**1958 Agreement – Consideration of draft amendments
to existing Regulations submitted by GRSP**

Proposal for Supplement 7 to the 04 series of amendments to Regulation No. 44 (Child restraint systems)

Submitted by the Working Party on Passive Safety *

Load application device I (to be used for Group 0 / 0+ products)

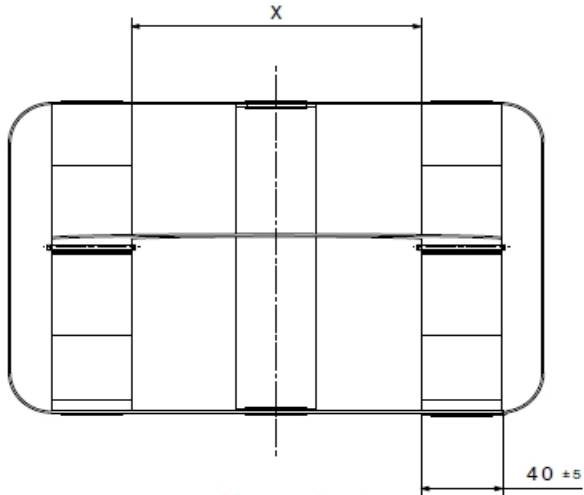
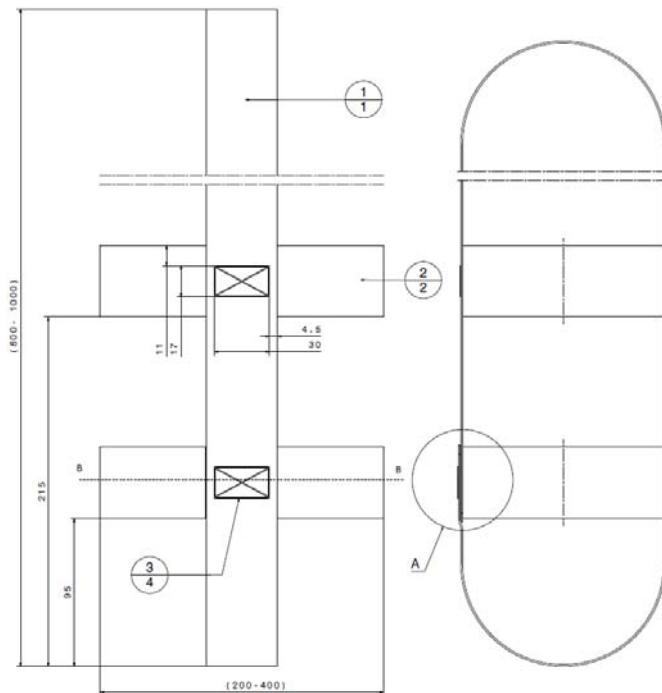
Insert a new Annex 23, to read:

"Annex 23

Load application devices
